# 2ND AND VIRGINIA

ITEM	BOARD GUIDANCE	RESPONSE
<b>1. Massing and Design Concept</b>	<p>The Board was supportive of the applicant's preferred massing alternative, Option C, as this option seemed to offer the most relief to the historic structure by setting back from the existing landmark building, the Terminal Sales Annex, on site and provided the strongest design concept (stepping massing) which created an interesting concept and means to breaking down the height, bulk, and scale of the proposed tower. Further the Board supported the location of the tower on site as the proposed tower siting provided setback from the Viktoria Tower to the south.</p>	<p><b>SUPPORTED BY EDG</b></p> <ul style="list-style-type: none"><li>• <b>The design team has incorporated the preferred design direction from the Board as the tower has evolved.</b></li></ul> <p><i>Thee following design guidelines will be better supported: A1 Respond to the Physical Environment, B3 Reinforce the Positive Urban Form &amp; Architectural Attributes of the Immediate Area.</i></p>

# RESPONSE TO BOARD GUIDANCE

Tower Form **1**

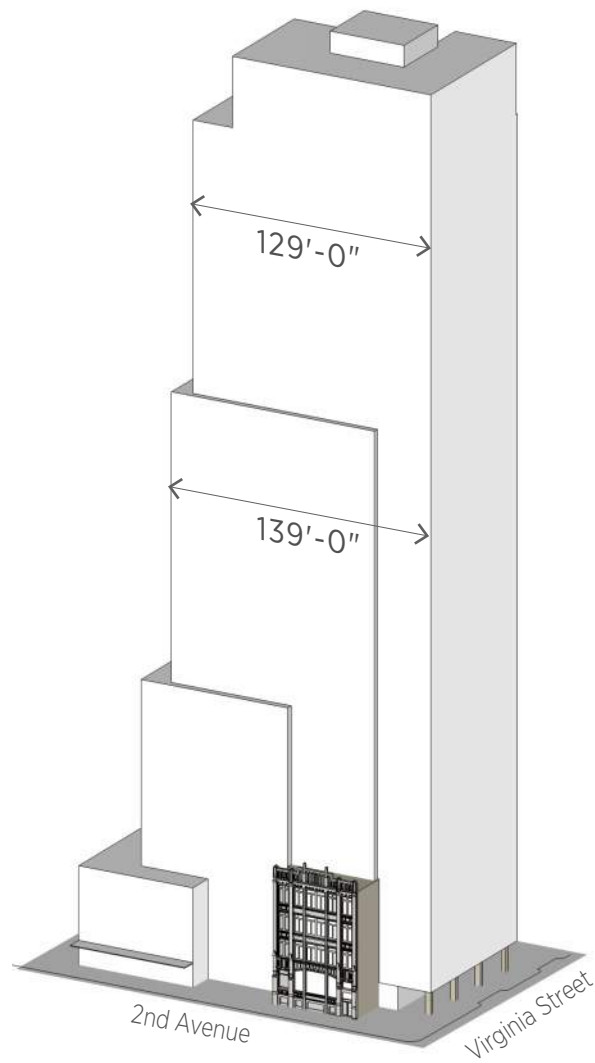
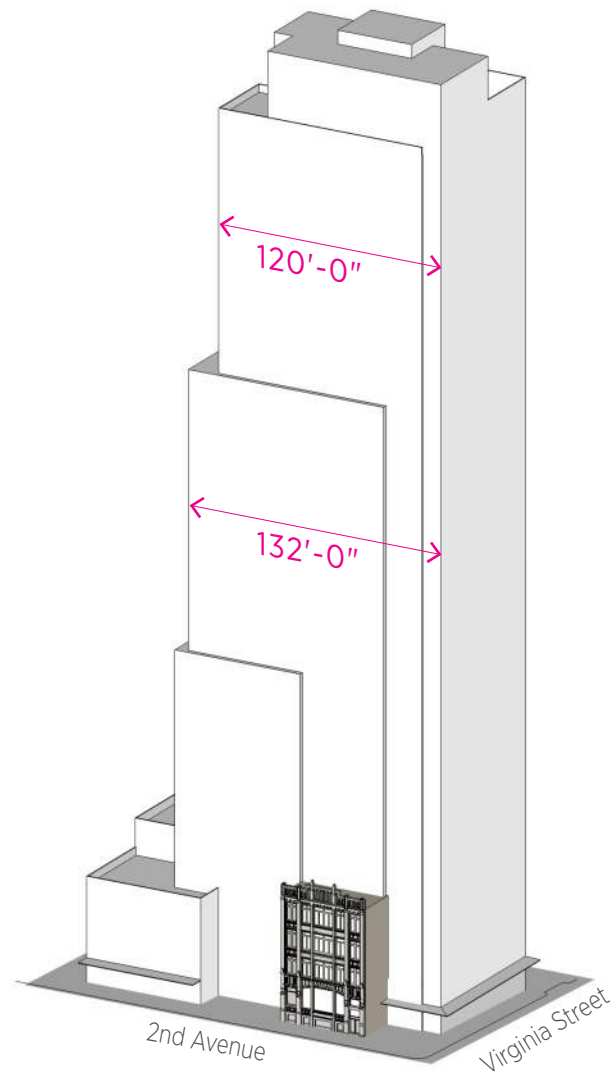
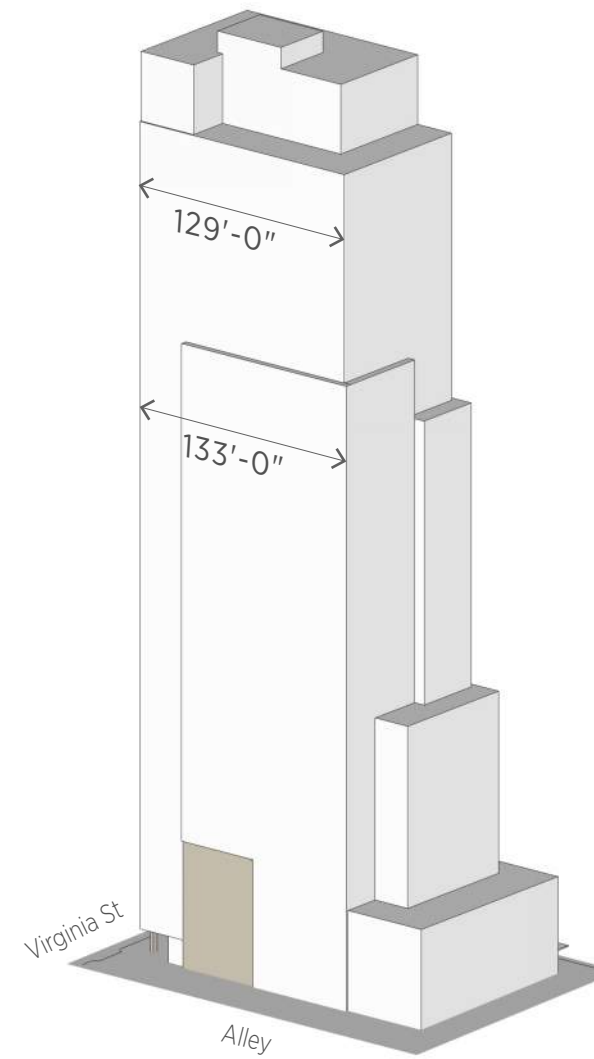
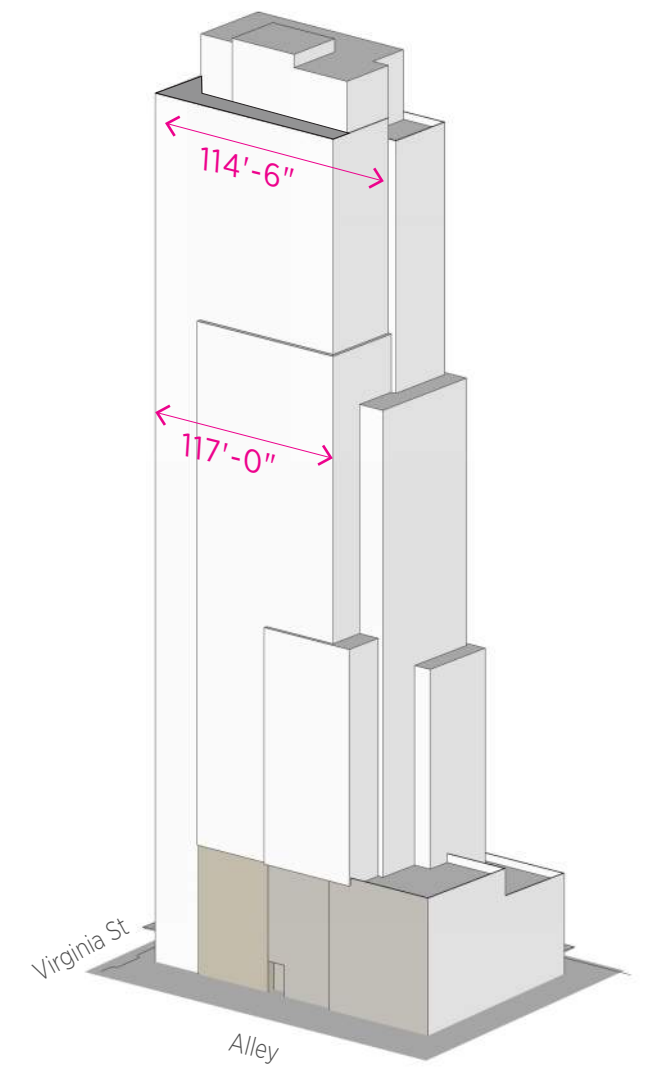
The Board was supportive of the concept of the stepping tower form as shown along 2nd Avenue. However, the Board commented it was not clear how the stepping would be carried around to all facades of the tower. At the next meeting the Board would like to review the following:

- i. Diagram of how the design concept is carried to all facades.
- ii. Clarification on how the tower form meets the podium and landmark structure.
- iii. Additional images of each facade, including images from both the City and pedestrian view.

**The Terminal Sales Annex sets up the alignments for the telescoping massing, and provides inviting and usable open plazas to highlight the landmark at the ground level.**

**In addition to reducing the tower width, the design team has increased the stepping on three sides of the building keeping the north facade as an unmodulated grounding element. Each tier of the telescoping forms wrap around from east facade to west facade, while the final and the tallest tier anchors the north facade, culminating in the tower terminus.**

- The overall tower width has been reduced.
- The average floor plate is well below the maximum average floor plate allowed.

## BAD EXAMPLES

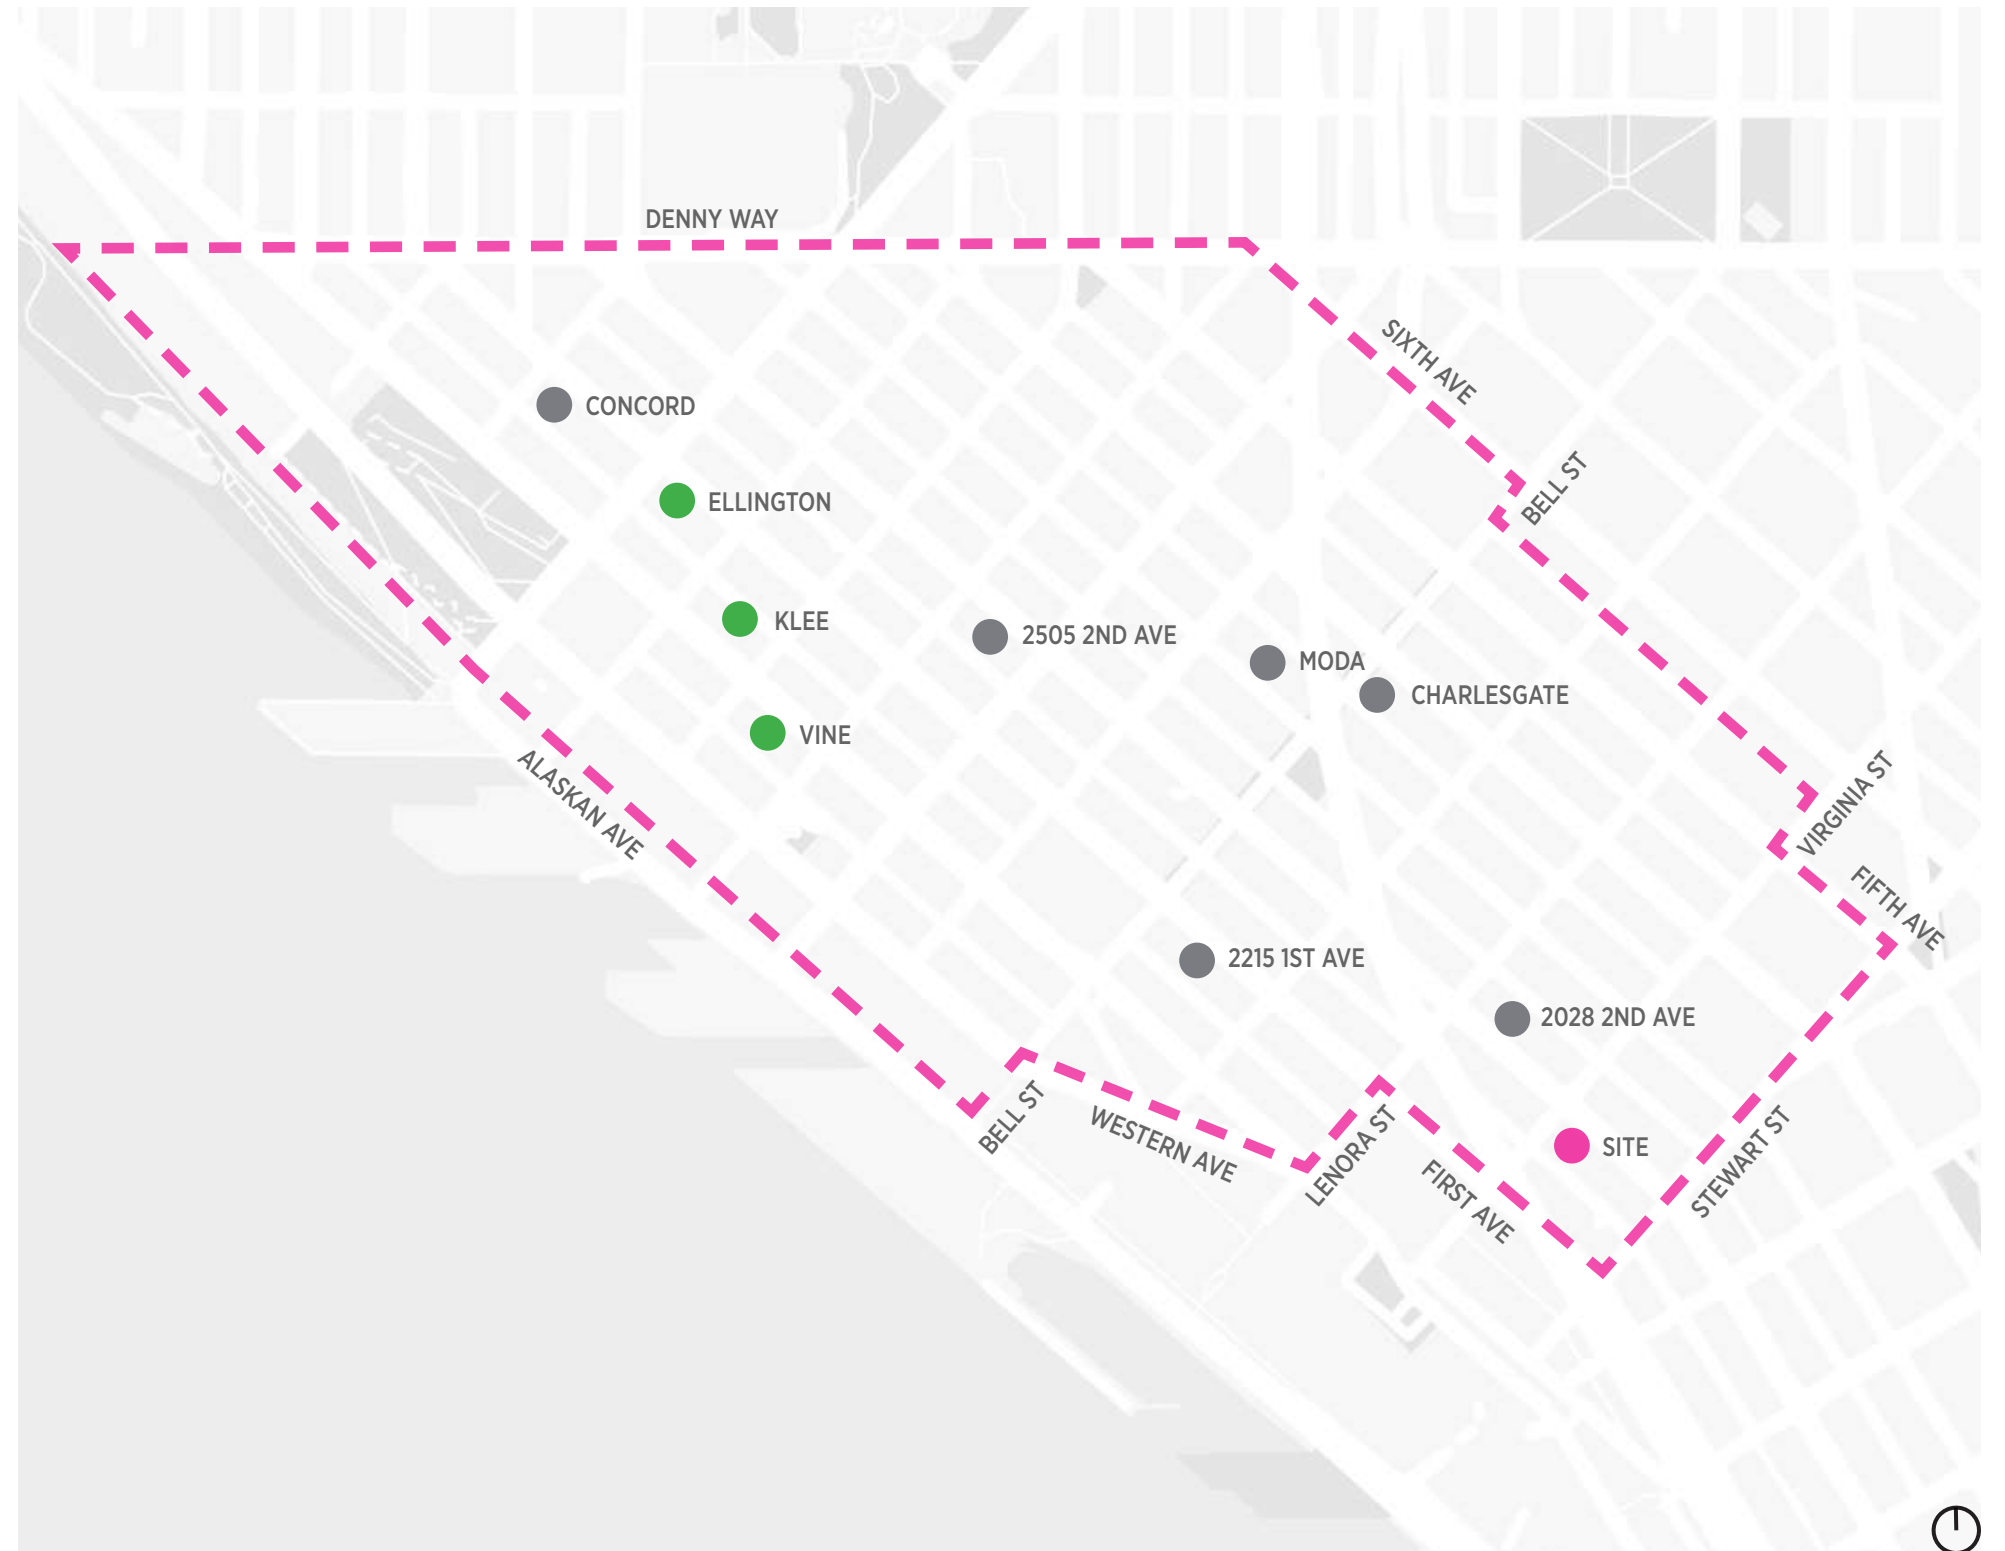
Overall the Board was pleased with the elevation at street-level along 2nd Avenue including the small open areas to the north and south of the landmark. However, the Board echoed public comment regarding the desire for an active street-level and expressed concern related to activation of the setback area becoming inactive, dead space. At the next meeting the Board would like more information related to these setback areas including:

- i. Study of good/bad examples of projects within Belltown that utilize larger setbacks/ entry courts.
- ii. Illustration of how programming and design of the adjacent uses and spaces will support activated areas. The Board specifically noted that lobby uses are of concern and should be designed thoughtfully with activation in mind.
- iii. Sections clarifying relationship to grade (along the entire street frontage).

**The project team has explored Belltown looking for good and bad examples of courtyards and mid-block plazas. The more successful examples all had human-scaled features such as planters, seating elements, artistic installations, etc. while encouraging flexibility in use.**

Charlesgate Apartment. : Gated courtyard is not contributing to public

KLEE Western & Cedar : Pleasant landscaping

EDG 1

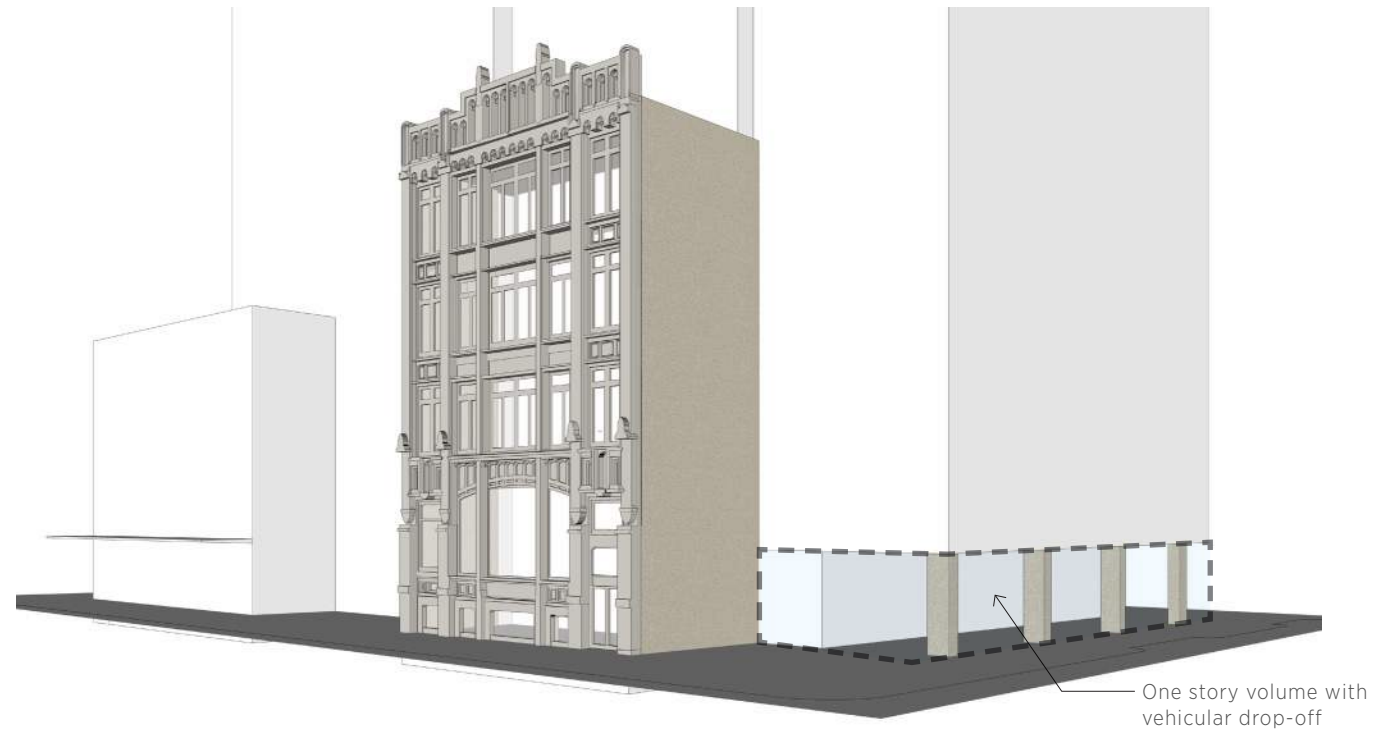
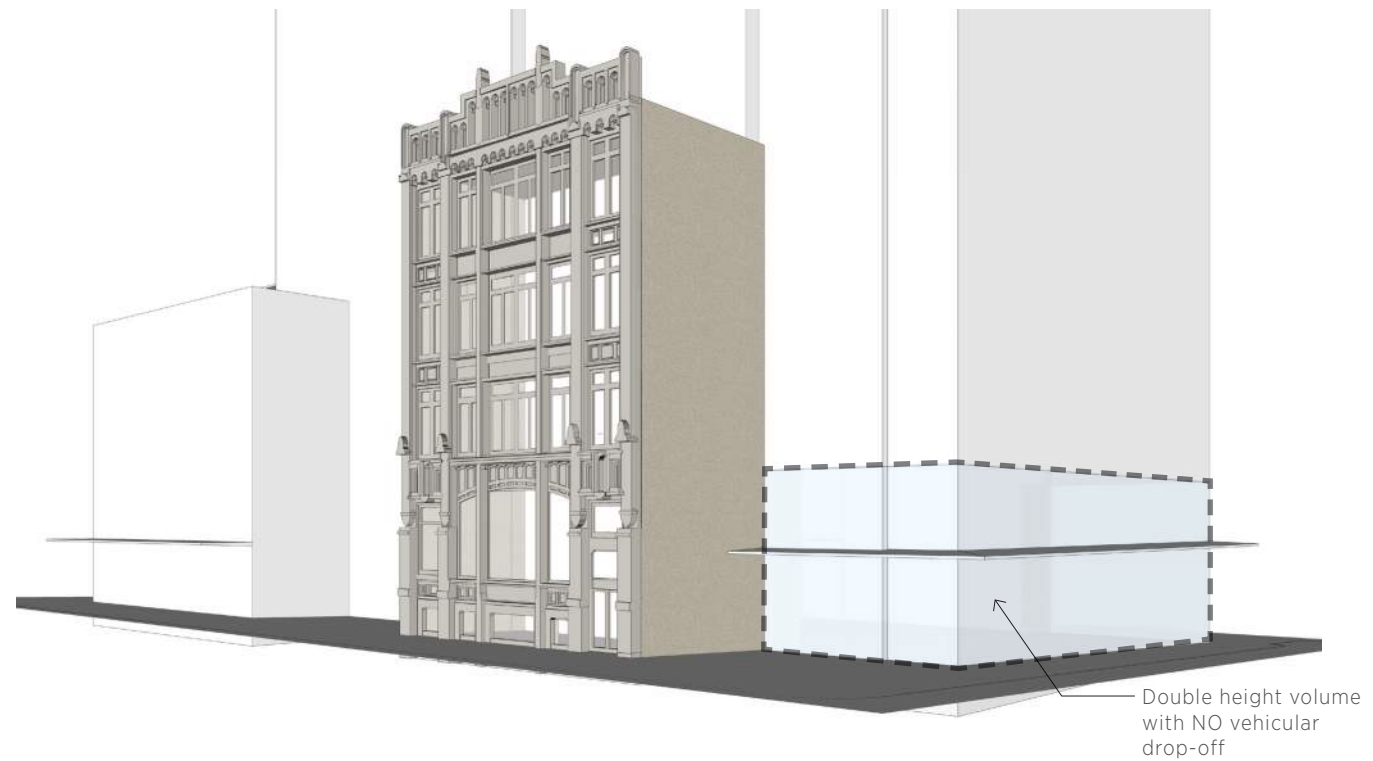
The Board echoed some public comment as they were not supportive of locating vehicular access off of Virginia Street as this interrupted the pedestrian experience both in terms of activation and safety of downtown streets by increasing curb cuts. The Board further noted that they have seen recent projects integrate porte cocheres successfully at the alley and questioned why this was not feasible. Though the Board acknowledged the challenges of programming uses around the core structure, they did not believe the presented design served as an asset to the pedestrian realm and commented the design was seemed to create a car focused area. At the next meeting the Board would like to see the following:

- i. Studies of alternative vehicular access location
- ii. Activated street response
- iii. Minimize curb cuts
- iv. Update on review of traffic information by SDOT/ SDCI transportation planner.

Per the recommendation of the Design Review Board, the project team has removed the vehicular drop-off area along Virginia Street. Instead, the street-level facade is occupied by active uses such as Cafe/Living room at the NE corner, hotel main entry, as well as residential entry and lobby/ lounge. This will create more active and safe pedestrian environment along Virginia Street.

In order to mitigate concerns regarding congested alley, the project sets back two additional feet for about 2/3 of the alley facade beyond the required 2ft alley dedication, creating safer and more usable alley.

## Departure 1

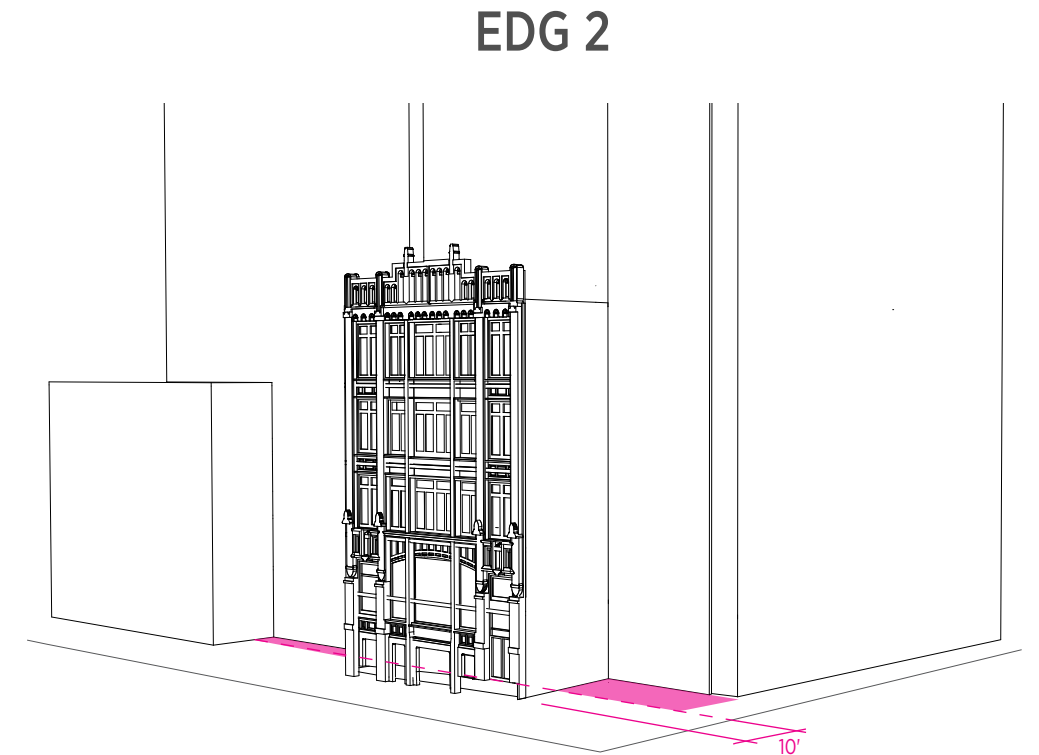
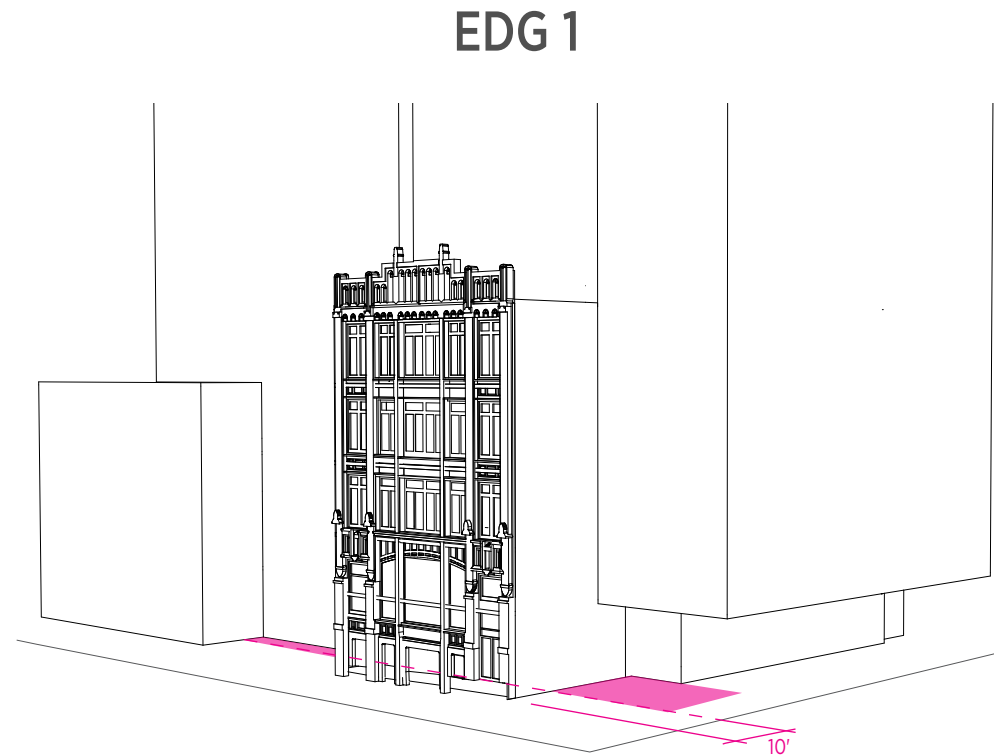
A departure is requested to setback the facades surrounding the Terminal Sales Annex (TSA) greater than 10'. We are requesting 15' on the south and 20.5' on the north.

South of the TSA: The #1 priority of the Landmarks Preservation Board (LPB) is to set back the new tower from the landmark structure. In conversations with the ARC over the years, a 15' setback is a reasonable starting point for tower setback from the Landmark. In this location, which supports our overall design concept, the tower form comes down the ground thus creating the 15' setback.

North of the TSA: As the tower begins to telescope and step back from the Landmark, the setback dimensions transition from 15' to 22' at the corner. This tower setback allows visibility to the Terminal Sales Annex and creates a grand open space to denote entry and respite for pedestrians.
